Accessibility Review Report – DA Review

Project Title: Gosford Regional Library
123A Donnison St, Gosford

Job Number: 20020

Report Version: 20020_ADR_DA_v1.4

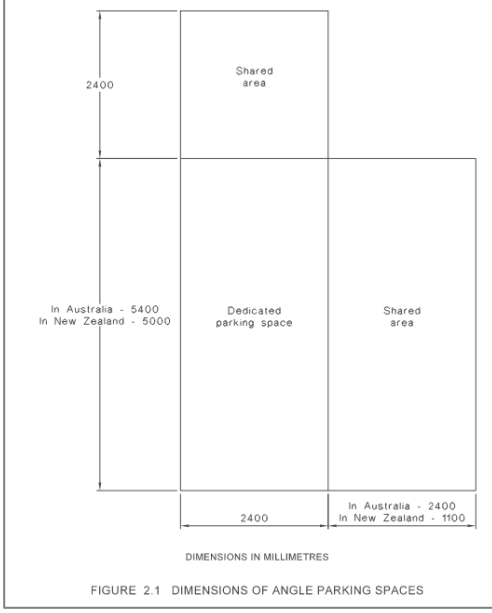
DtS Provision	Comment(s)/Recommendation(s)	Status
In a building required to be accessible every ramp and stairway, except for ramps and stairways in areas exempted by D3.4, must comply with –		
<ul style="list-style-type: none"> • for a ramp, except a fire-isolated ramp, clause 10 of AS 1428.1; and 	<p>All non-fire-isolated ramps are required to comply with AS1428.1-2009.</p> <p>Compliance is readily achievable with minor design development and/or specification at the Detailed Design Stage.</p>	DD
<ul style="list-style-type: none"> • for a stairway, except a fire-isolated stairway, clause 11 of AS 1428.1; and 	<p>All non-fire-isolated stairways are required to comply with AS1428.1-2009.</p> <p>Compliance is readily achievable with minor design development and/or specification at the Detailed Design Stage.</p>	DD
<ul style="list-style-type: none"> • for a fire-isolated stairway, clause 11.1(f) and (g) of AS 1428.1; and 	<p>Compliance is readily achievable.</p> <p><i>N.B. – Cl. D2.17(a)(vi) of the BCA is generally assessed by the PCA / BCA Consultant. Where assessment of this</i></p>	CoC

<i>Clause is required by this office please confirm and provide detail.</i>	
<p>Accessways must have—</p> <ul style="list-style-type: none"> • passing spaces complying with AS 1428.1 at maximum 20 m intervals where a direct line of sight is not available • turning spaces complying with AS 1428.1 at 20m intervals or within 2m of the termination of an accessway. 	Compliance is readily achievable with minor design development at the Detailed Design Stage.	DD
